# **Indeck Niles, LLC**

## **RESPONSE TO COMMENTS DOCUMENT**

**January 4, 2017**

**PERMIT No. 75-16**

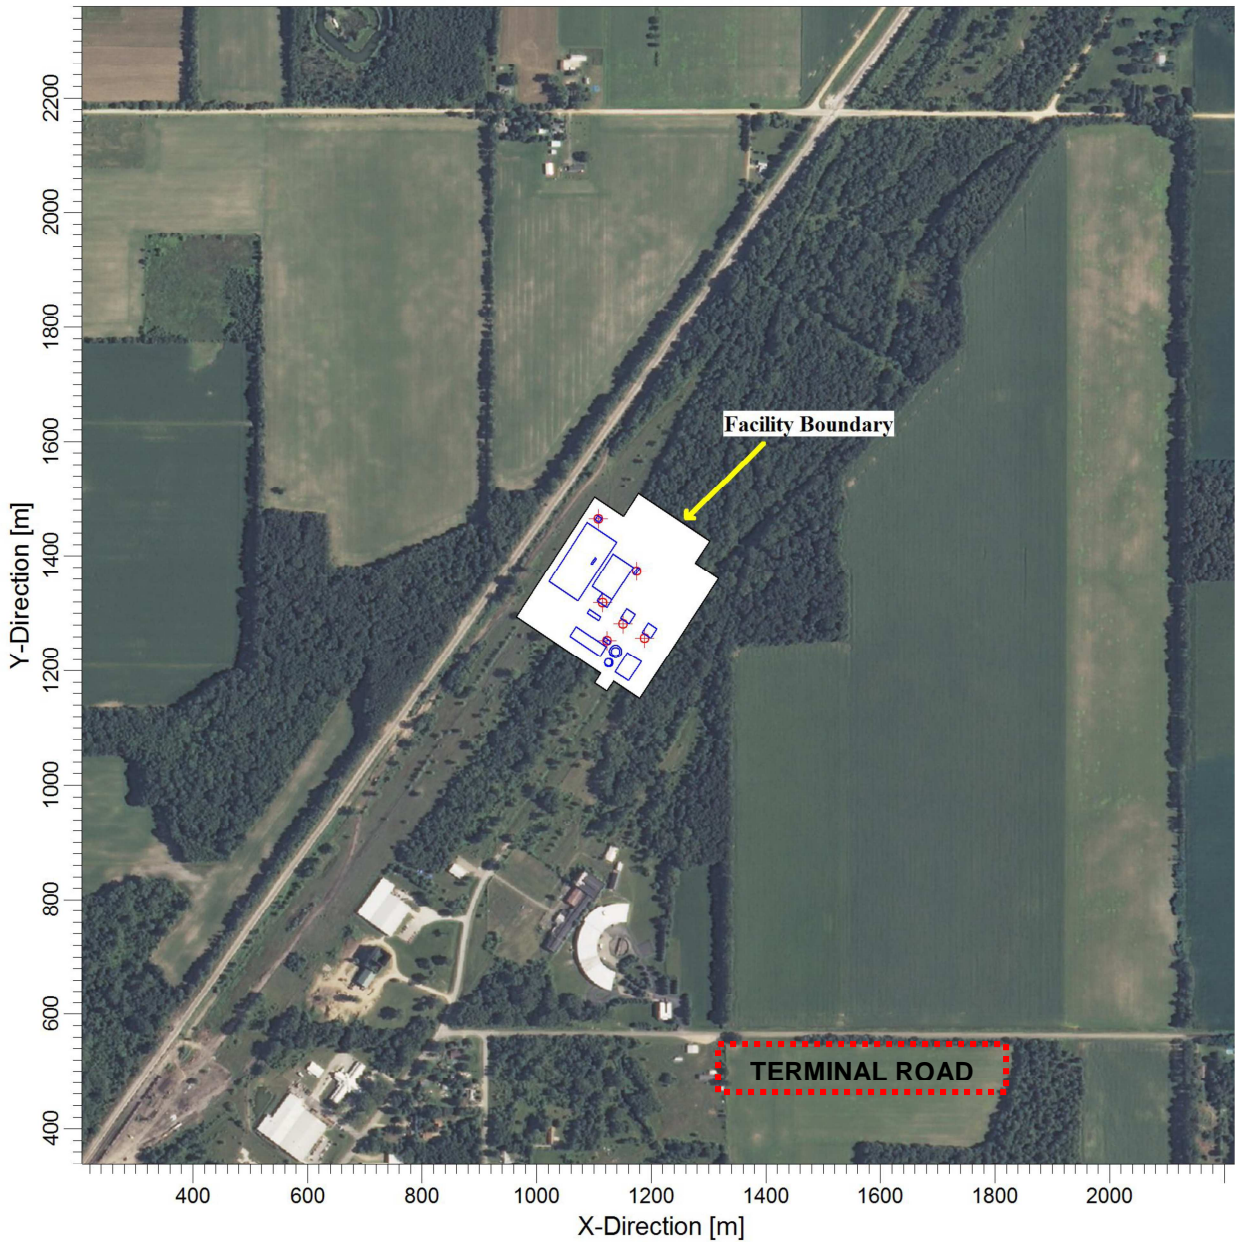
What is the plot of land it is going to sit on, will it shift at all? Will it go more toward White Street or be more toward the high school and the airport?

Indeck has already purchased its proposed location at 2200 Progressive Drive. Their application included dispersion modeling based upon this location and specific building and exhaust stack designs. Any changes to the location and/or designs would result in Indeck needing to submit a new application to the AQD. Below is a map of the proposed site:
